Responses to RC1:

This manuscript presents the calibration algorithms used for the ACDL lidar onboard the DQ-1 satellite, with the analysis of the 532 nm nighttime polarization and high-spectral-resolution channels. The study is of significant interest to the lidar community, particularly as the launch of the EarthCARE ATLID lidar in May 2024 presents opportunities for comparative analyses between these two advanced lidar systems. This paper was originally submitted in May 2024, and my previous reviewer comments, along with the authors' responses, are available at: <https://egusphere.copernicus.org/preprints/2024/egusphere-2024-588/> under Anonymous Referee #1.

Responses to RC2:

The manuscript describes the nighttime calibration of the spaceborne HSR lidar ACDL/DQ-1. It is important to clarify how the signals are calibrated. There is some heritage of the CALIPSO mission, and something to learn for the new EarthCARE mission. At parts the authors present great details, but at others the authors go rather quick over some issues. In general, the paper is good and should be published after major revisions.

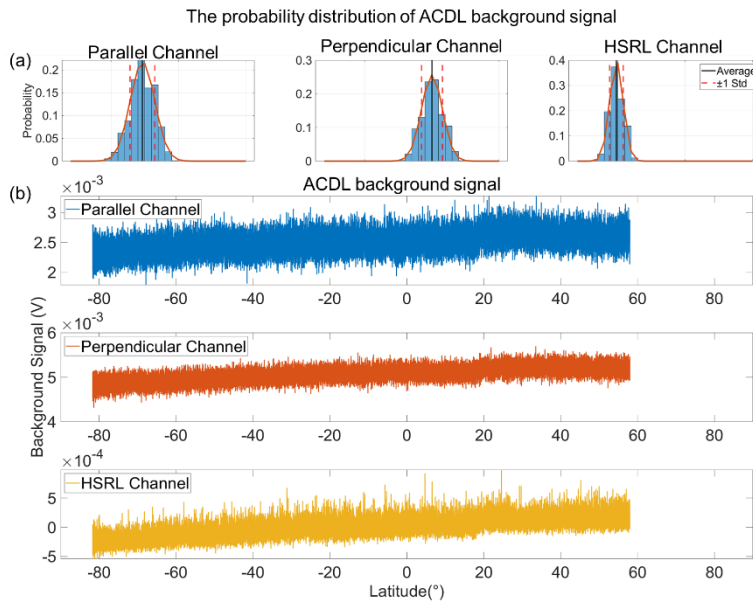
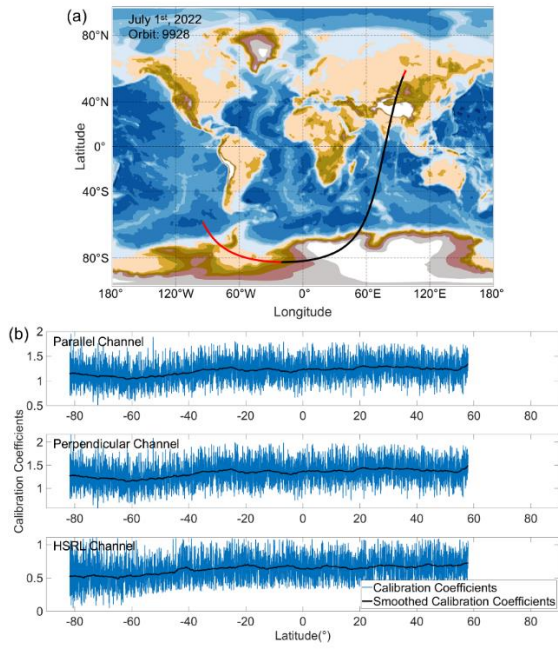
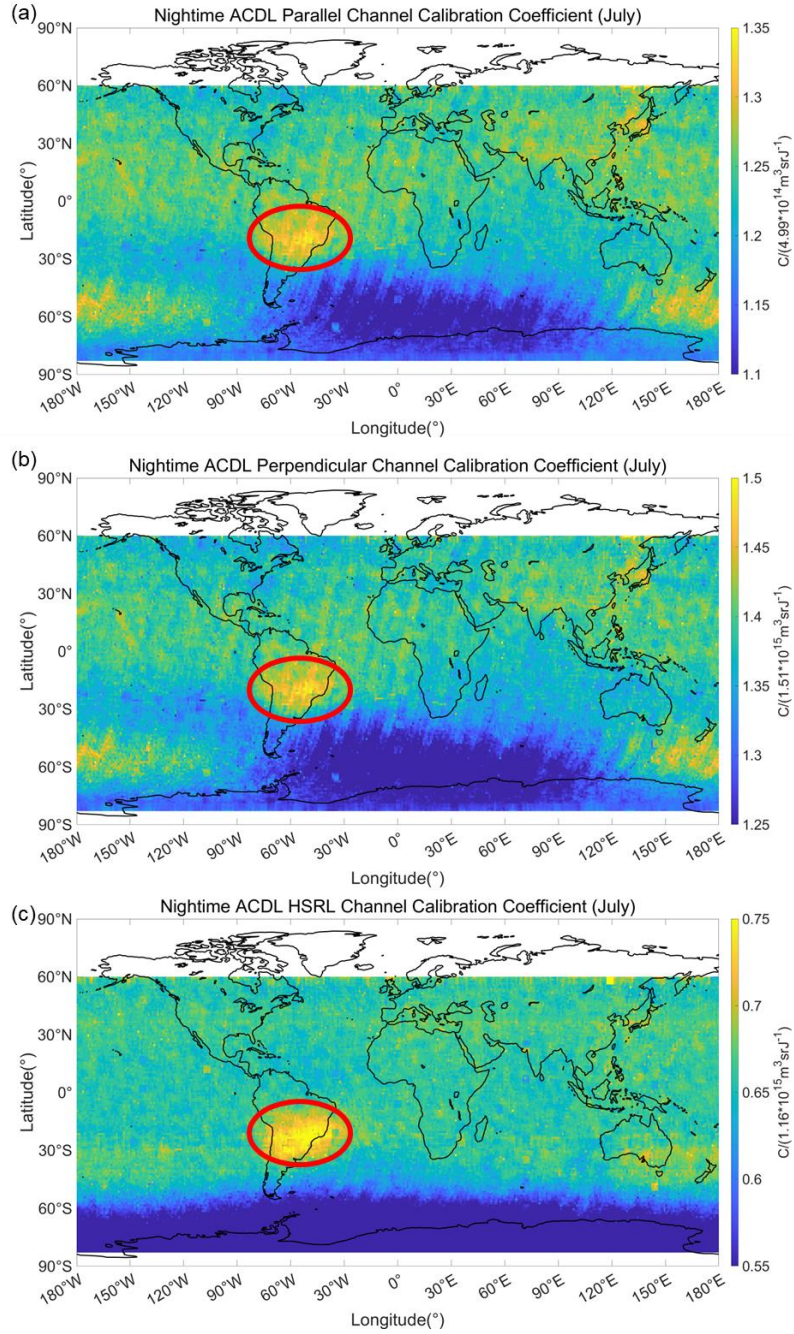
1. Please show the calibration of the cross-polarized channel as well. I am not satisfied to state that it is the same except with the polarization gain ratio (PGR). You might provide in the supplement all the figures for the cross-polarized channel which you have provided for the parallel-polarized and HSRL channel in the manuscript.

AR: Thank you for raising this issue. We have included the results of perpendicular channel background signal and calibration coefficients in Figure 2, Figure 7 and Figure 14.

Figure 6: Transmittance function (black line) of (a) the iodine vapor absorption filter (green dotted line means the center wavelength, and multiple color curves means normalized Rayleigh scattering function at 30–40 km) and (b) the F-P etalon.

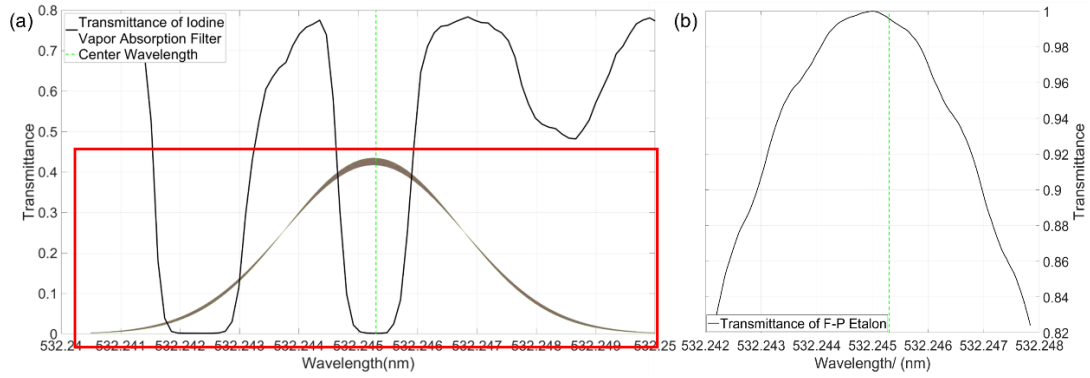
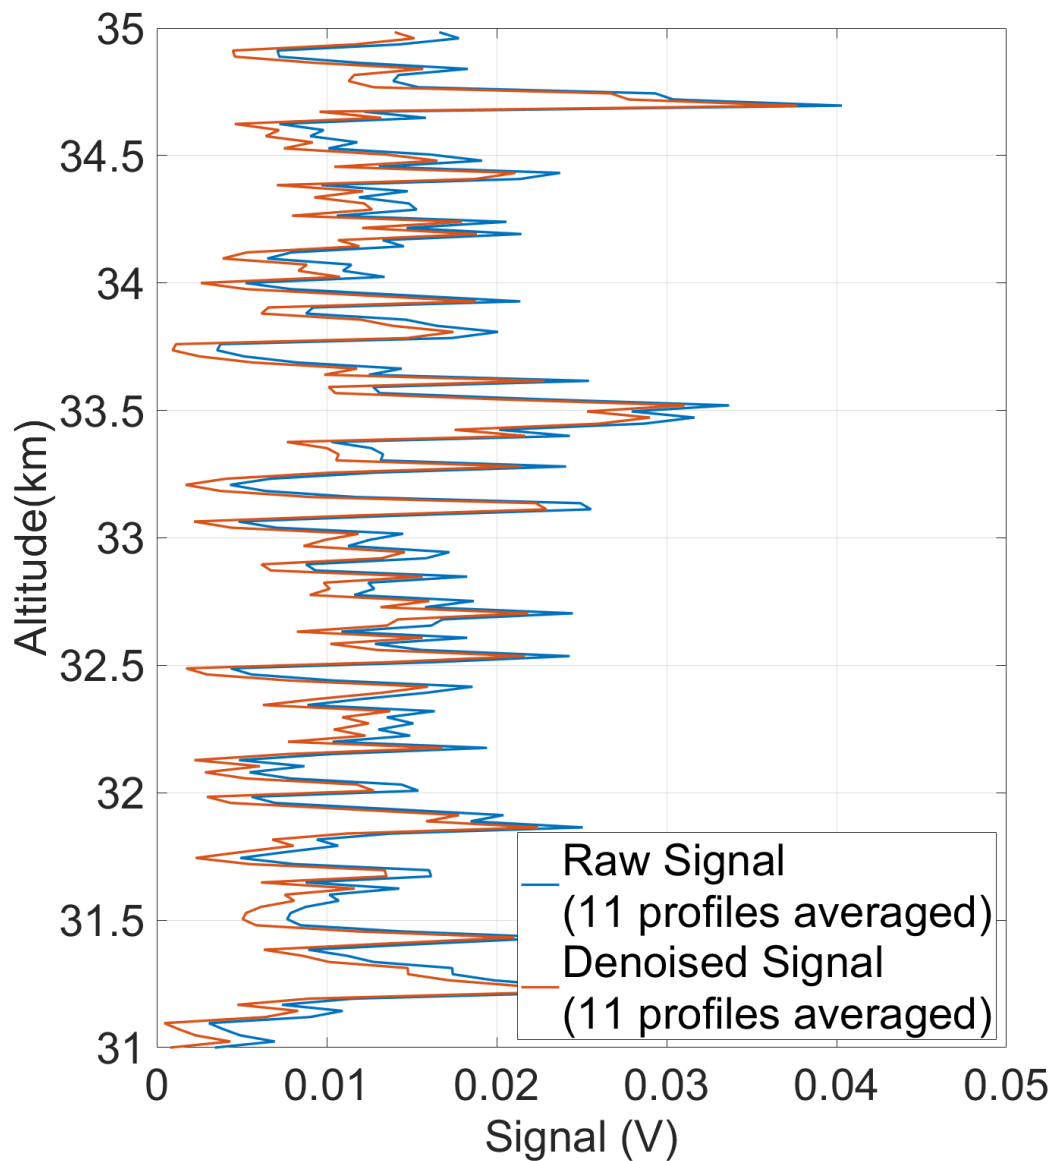
5. You nicely characterize the iodine vapor cell in Fig 6. But how does the Fabry-Perot etalon perform? Please comment on it and add some more details about it.

AR: Thank you for pointing out this issue. As shown in the figure below, the transmission of the F-P etalon remains above 0.85 near the center wavelength (532.2453 nm), which is able to completely cover the broad range of molecules in the upper atmosphere. And the transmittance of the F-P etalon

is calculated by eq. 22. In the revised manuscript, we have modified the Figure 6:

Figure 12: Lidar 532 nm total attenuated backscatter coefficient ($\text{m}^{-1}\text{sr}^{-1}$, 1 July 2022). The clear-sky regions are illustrated by red boxes, spanning 200 km in length and ranging from 26 to 30 km in altitude. The upper right figure displays the range of track (black line).

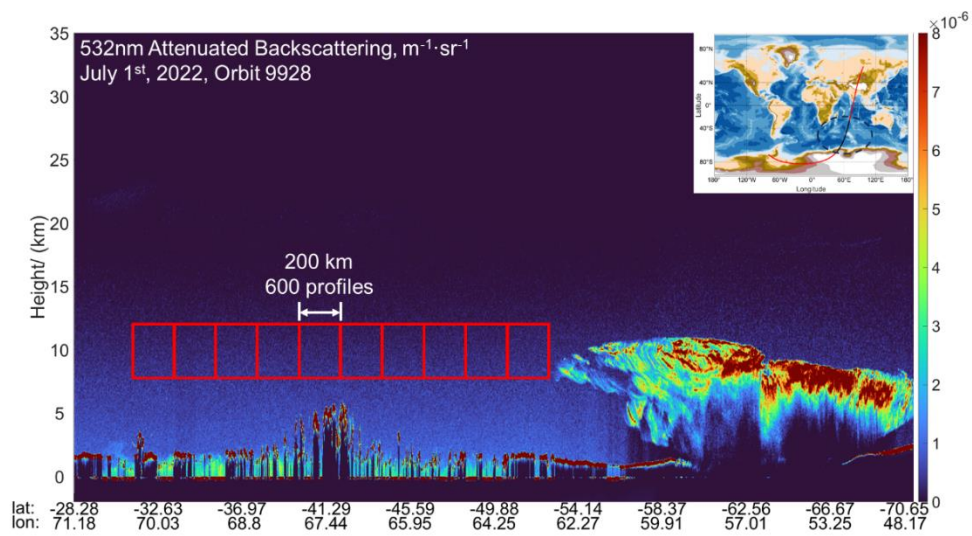
8. I am a bit puzzled about your low altitude verification. Why do you use the 8 – 12 km height range?

In Fig. 12, you mark the red boxes at 26 – 30 km height, because obviously between 8 and 12 km is the huge cirrus cloud. In other words, aerosol particles and clouds are often present in the 8 – 12 km range. So, I would not expect a scattering ratio of 1 in this height range. The 1.03 shown in Fig. 13 seem to be reasonable. However, you cannot conclude on your calibration, because the true value is maybe not 1.0 but a bit higher.

AR: We feel sorry for our carelessness. An error was identified in Figure 12 of the manuscript, which has been revised in the manuscript by adjusting the red box to the correct position. In the 8-12 km, the presence of aerosols and clouds. To ensure the validity of the study, a clear sky area devoid of clouds was selected as the study area, thereby minimizing the impact of cloud effects. Given the uncertainty surrounding the estimation of aerosols, it was assumed that the 8-12 km range does not contain aerosols under clear-sky conditions, thus providing a reference value of 1 (Powell et al., 2009). However, the ACDL measurements indicate that the impact of aerosols in this region, with actual measurements exhibiting fluctuations around 1.03.

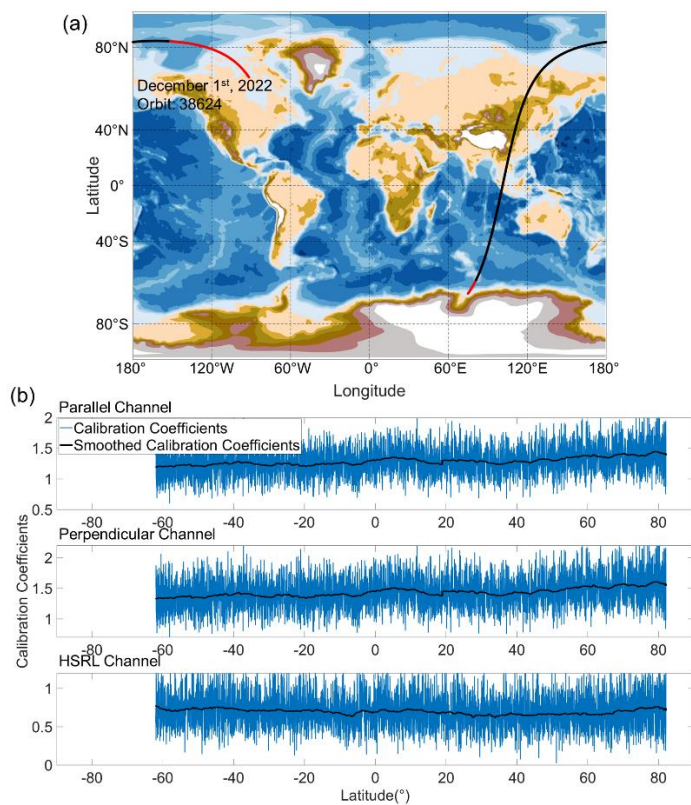
10. One should separate between verification and validation. Validation always includes external observations (suborbital or from another satellite), whereas verification can be done with only one's own data. In your case, you present verification and refer to Liu et al., 2024, for validation. Maybe some more comments on the validation presented in the other paper might be helpful at this point.

AR: We are grateful for the valuable advice. We have revised the assessment by using ACDL data to verification in section 3.2, and provided a detailed description of the validation work carried out

using ground-based lidar.

L518: “As a supplement, the validation of ACDL profiles have conducted a profile comparison utilizing a dual-wavelength polarization Raman lidar the (Belt and Road lidar network, BR-lidarnet, initiated by Lanzhou University in China) and the CALIPSO satellite. The profiles of the total attenuated backscatter coefficient (TABC) and the volume depolarization ratio (VDR) at 532 nm were compared by three lidar system in six cases. The findings indicate that the relative deviation between the ACDL and ground-based lidar measurements was approximately $-10.5 \pm 25.4\%$ for the TABC and $-6.0 \pm 38.5\%$ for the VDR (Liu et al., 2024). The observed discrepancies can be attributed to the presence of systematic errors in the ACDL, as well as measurement errors associated with the ground-based lidar. Additionally, ACDL exhibited a high degree of consistency when compared with the observations made by CALIPSO (Liu et al., 2024; Zha et al., 2024). The validation results further demonstrate the accuracy of the calibration algorithm. “

The calibration coefficients for each calibration region (orbit 38624 for December 1st, 2022)

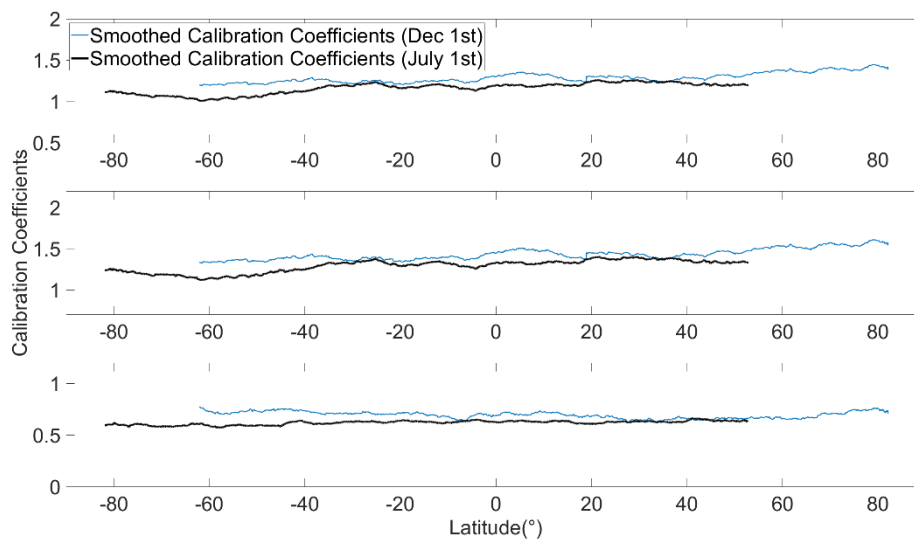
11. The results are shown for observations in 2022. Could you comment on the stability of the calibration constant over the years, e.g., by showing an example from 2024. Does the calibration constant changes with time?

AR: Thanks for your kind reminder. The calibration coefficients are known to undergo changes over time due to alterations in on-orbit operational status. These changes are currently under observation and analysis. The figure below shows the results of the calibration coefficients for the example orbit in December 1st, 2022.

Figure 14: Result of global calibration coefficient on a 1° latitude \times 1° longitude grid for July, 2022.

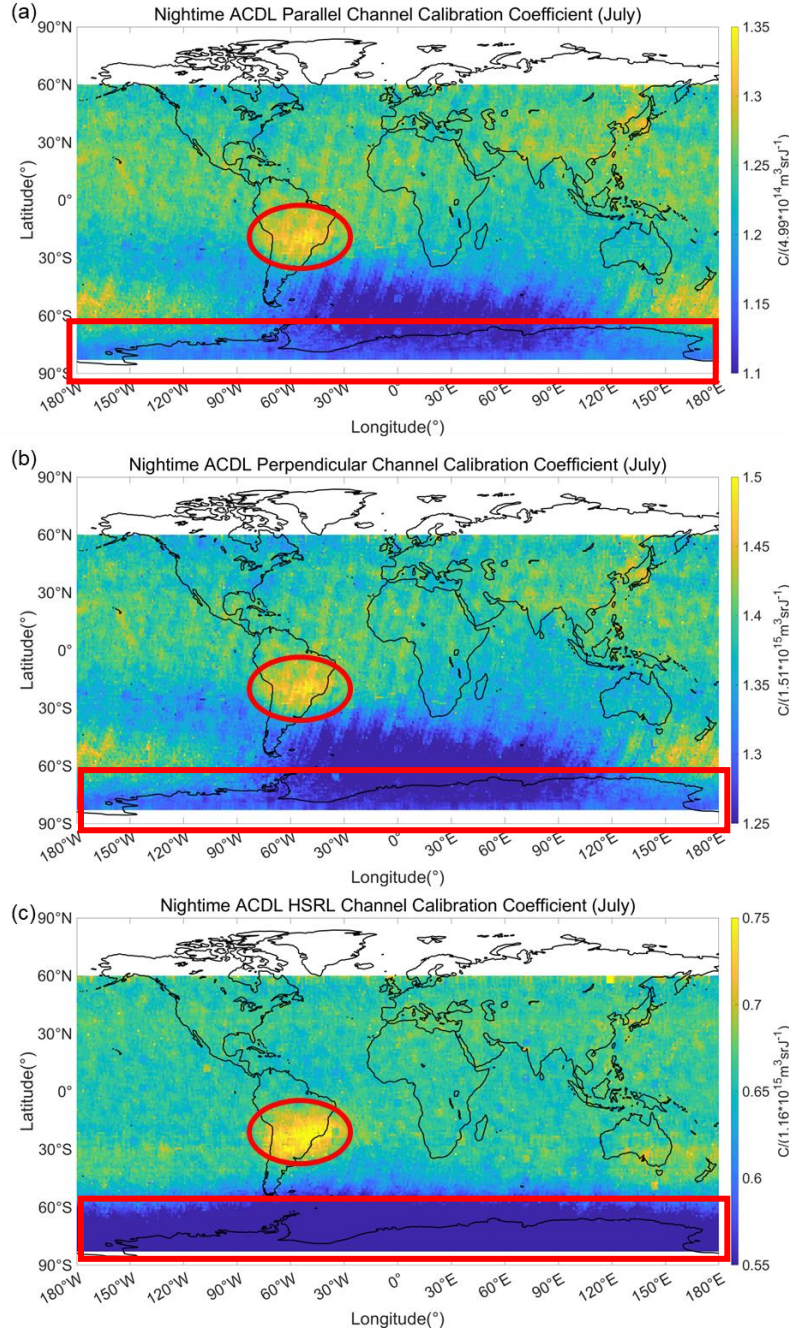
9. The behavior of the calibration constant in Fig. 14 misses any explanation except the SSA. Why does the southern Pacific Ocean behave differently than the same latitudes over the Atlantic and Indian Ocean?

AR: Thanks for your kind reminder. The observed variation in calibration coefficients at a given latitude is near the South Pole attributable to the uneven distribution of auroras within the Antarctic polar night region (as shown in figure below) during July. This phenomenon underscores the inadequacy of prevailing background signal acquisition algorithms in mitigating noise from the aurora in polar regions. Subsequent algorithm updates will address this shortcoming through

enhanced analysis and refinement. And the relevant descriptions in the manuscript have been revised:

L529: "In addition, elliptical regions of increased calibration coefficients near the poles can be seen, due to auroras near the poles (Hunt et al., 2009). " ➔

"In addition, elliptical regions (the latitude is near the South Pole) of increased calibration coefficients near the poles can be seen, due to auroras near the poles (Hunt et al., 2009). "

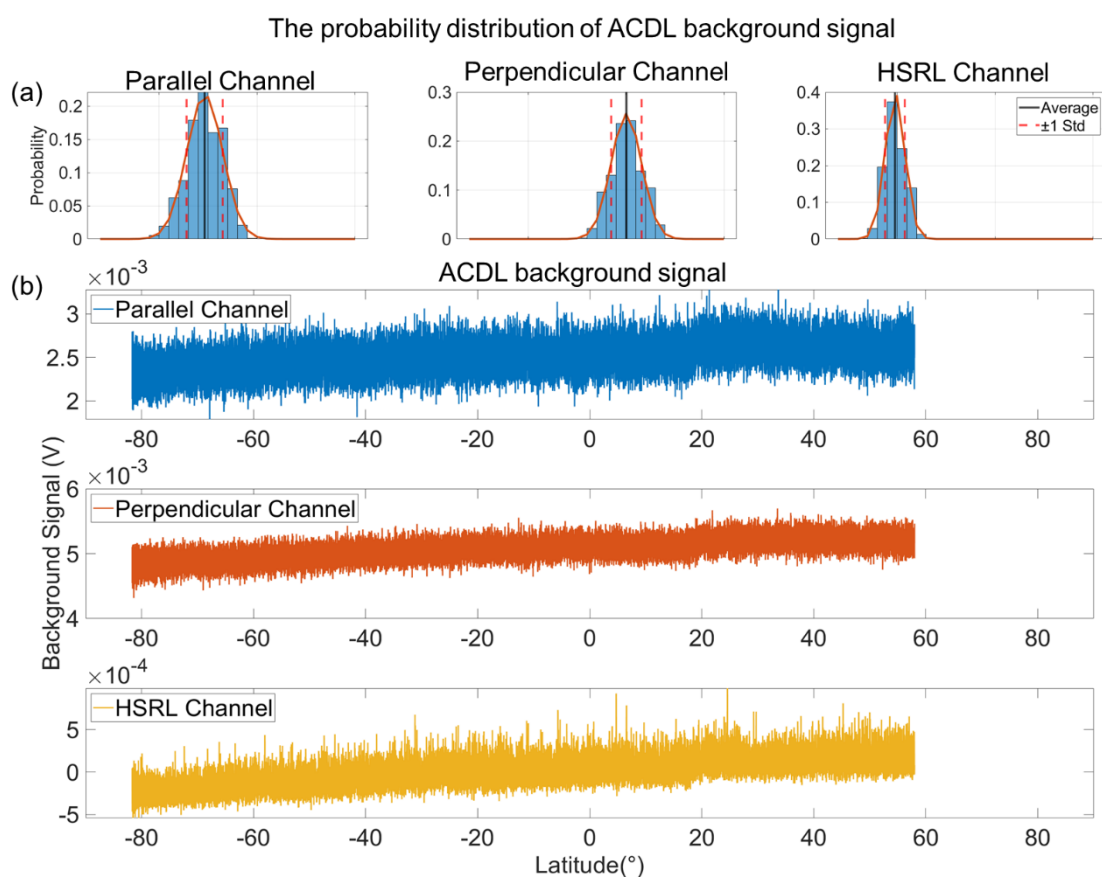
4. In Fig. 2 – Could you provide a date for the orbit? And please already state a bit earlier, that during summertime there is daylight north of 60°N.

AR: We feel sorry for our carelessness. In the revised manuscript, we have incorporated orbital dates into the caption of Figure 2, updated the normal distribution curves, and included the following description:

L124: “The data from July 1, 2022 (orbit 9928), was selected for the subsequent background signal illustration, encompassing a latitude range from -80°S to 58°N, comprise only the nighttime data. ”

Figure 6: Transmittance function (black line) of (a) the iodine vapor absorption filter (green dotted line means the center wavelength, and multiple color curves means normalized Rayleigh scattering function at 30–40 km) and (b) the F-P etalon.

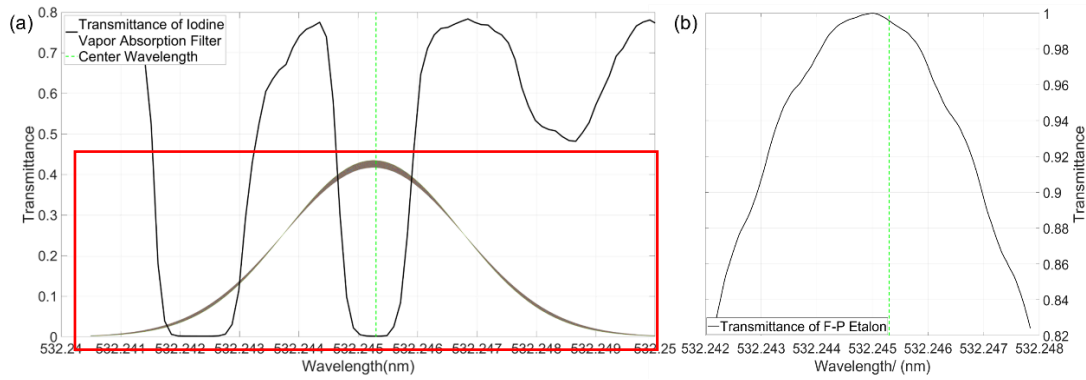
8. L258-260: Unclear formulation. What do you mean with additional schema in Fig. 6? The F-P etalon? Please discuss the F-P etalon in greater detail (see major comment above).

AR: Thank you for pointing out this issue. The additional schema in Fig. 6 (red box in figure below) means normalized Rayleigh scattering function at 30–40 km. And the transmittance of the F-P etalon has added in the Figure 6:

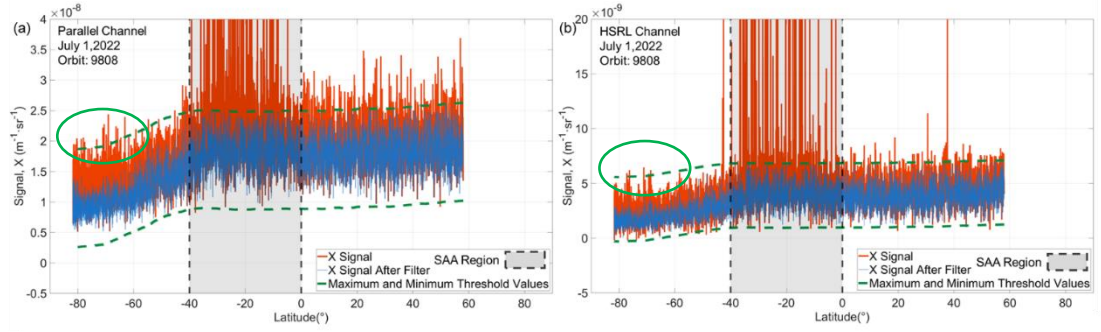
13. Fig. 8+9 Please show the cross polar channel as well (or in the supplement).

AR: Thanks for your kind reminder. The research was utilized the Eq. 23 to calculate the calibration coefficients of the perpendicular channel. It should be noted that the perpendicular channel signals do not undergo the data filter described in the algorithm. Consequently, only the diagrams for the parallel and HSRL channels are provided in the manuscript (see Figures 8 and 9).
